SUBJECT: REQUEST FOR ADDITIONAL INFORMATION REGARDING IPEEE
SUBMITTAL - PERRY NUCLEAR POWER PLANT, UNIT NO. 1
(TAC NO. M83659)

**Request for Additional Information
Perry IPEEE**

Figure R.1 Sensitivity of the hot gas layer temperature predictions to the assumed heat loss factor

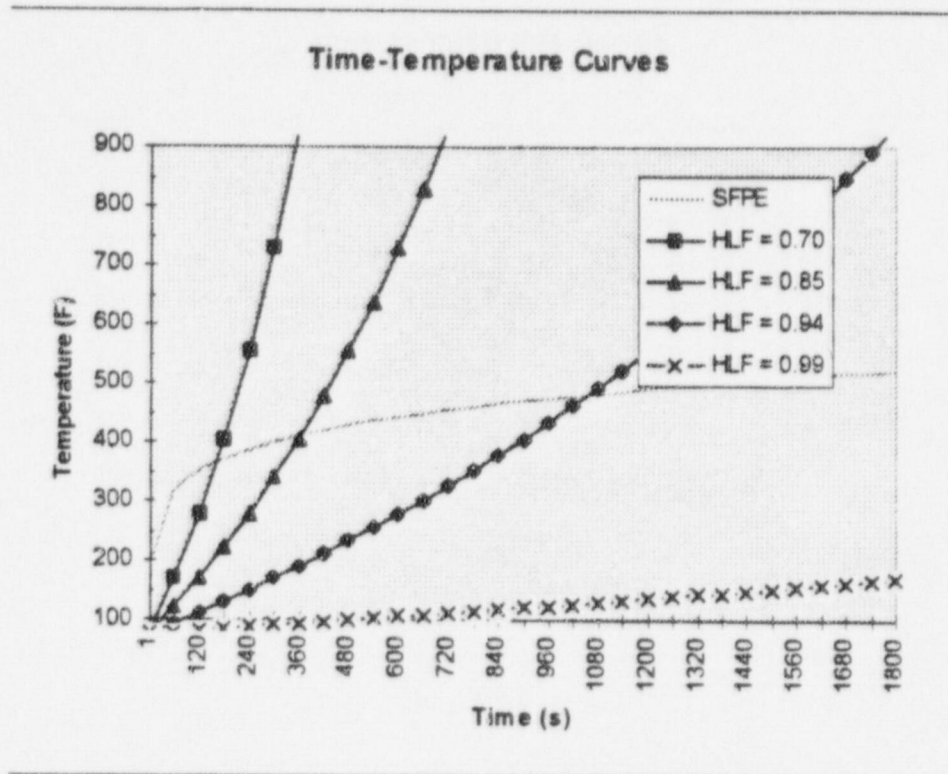
7. The heat loss factor is defined as the fraction of energy released by a fire that is transferred to the enclosure boundaries. This is a key parameter in the prediction of component damage, as it determines the amount of heat available to the hot gas layer. In Fire-Induced Vulnerability Evaluation (FIVE), the heat loss factor is modeled as being inversely related to the amount of heat required to cause a given temperature rise. Thus, for example, a larger heat loss factor means that a larger amount of heat (due to a more severe fire, a longer burning time, or both) is needed to cause a given temperature rise. It can be seen that if the value assumed for the heat loss factor is unrealistically high, fire scenarios can be improperly screened out. Figure R.1 provides a representative example of how hot gas layer temperature predictions can change assuming different heat loss factors. Note that: 1) the curves are computed for a 1000 kW fire in a 10m x 5m x 4m compartment with a forced ventilation rate of 1130 cfm; 2) the FIVE-recommended damage temperature for qualified cable is 700°F for qualified cable and 450°F for unqualified cable; and, 3) the SFPE curve in the figure is generated from a correlation provided in the Society for Fire Protection Engineers Handbook [R1].

Based on evidence provided by a 1982 paper by Cooper et al. [R2], the *EPRI Fire PRA Implementation Guide* recommends a heat loss factor of 0.94 for fires with durations greater than five minutes and 0.85 for "exposure fires away from a wall and quickly developing hot gas layers." However, as a general statement, this appears to be a misinterpretation of the

results. Reference [R2], which documents the results of multi-compartment fire experiments, states that the higher heat loss factors are associated with the movement of the hot gas layer

from the burning compartment to adjacent, cooler compartments. Earlier in the experiments, where the hot gas layer is limited to the burning compartment, Reference [R2] reports much lower heat loss factors (on the order of 0.51 to 0.74). These lower heat loss factors are more appropriate when analyzing a single compartment fire.

In summary, (a) hot gas layer predictions are very sensitive to the assumed value of the heat loss factor; and (b) large heat loss factors cannot be justified for single-room scenarios based on the information referenced in the *EPRI Fire PRA Implementation Guide*.

The Perry IPEEE fire study discusses heat loss factors only in conjunction with the detailed analysis of electrical cabinets in one fire compartment (1CC3a). No hot gas layer (HGL) temperature is estimated and HGL effects are apparently not considered important based on test data and referenced information that could not be verified. HGL effects were apparently also considered in other detailed compartment analyses.

For each scenario where the hot gas layer temperature was calculated, please specify the heat loss factor value used in the analysis. In light of the preceding discussion, please either: a) justify the value used and discuss its effect on the identification of fire vulnerabilities, or b) repeat the analysis using a more justifiable value and provide the resulting change in scenario contribution to core damage frequency.
